# Access Compliance Report

## Public Rights-of-Way

### (Curb Ramps)

Intersection ID: 47231	Main Street: ROMANY_RD	Cross Street: MOREHEAD_MEDICAL_DR	Location: NE
ADA ID: 3139CD0985A6	Ramp Type: BlendTrans1	Initial Pass/Fail: Fail	Overall Compliance: No
			Severity Score: 21.25

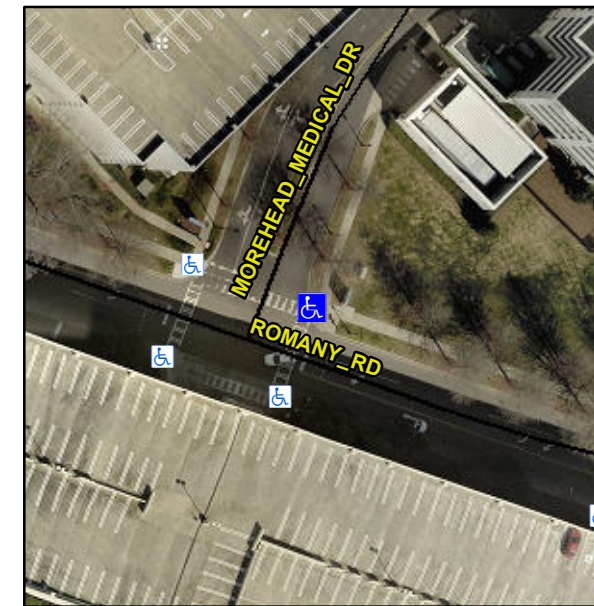
**R304.5.1, R304.5.3**

Compliance	Description	Data	Compliance	Description	Data
N/A	Ramp Length (in)	36.0	Yes	BlendTrans Slope (%)	1.4
No	Ramp Width (in)	47.0	No	BlendTrans XSlope (%)	6.7
N/A	Flare Type LT	N/A	N/A	Flare Type RT	N/A
N/A	Flare Slope LT (%)	N/A	N/A	Flare Slope RT (%)	N/A
N/A	Flare Traversable LT?	N/A	N/A	Flare Traversable RT?	N/A
N/A	Landing Length (in)	N/A	N/A	DWS Provided?	N/A
N/A	Landing Width (in)	N/A	N/A	DWS Contrast?	N/A
N/A	Landing Slope (%)	N/A	N/A	DWS Length (in)	N/A
N/A	Landing X Slope (%)	N/A	N/A	DWS Full Width?	N/A
N/A	Landing Curb? (Y/N)	N/A	N/A	DWS Offset (in)	N/A
N/A	Shared Landing?	N/A			
N/A	Gutter Ponding?	N/A	N/A	Gutter Slope (%)	N/A
N/A	Gutter Lip Ht (in)	N/A	N/A	Gutter X Slope (%)	N/A
N/A	Painted X Walk1?	Yes	N/A	Painted X Walk2?	Yes
	X Walk 1 Direction	To NW		X Walk 2 Direction	To SW
	X Walk 1 Width (in)	69.0		X Walk 2 Width (in)	67.0
	X Walk 1 Slope (%)	0.8		X Walk 2 Slope (%)	7.3
	X Walk 1 X Slope (%)	6.6		X Walk 2 X Slope (%)	0.6

**Remove & Replace Curb Ramp With Two New Directional Ramps or Equivalent.**
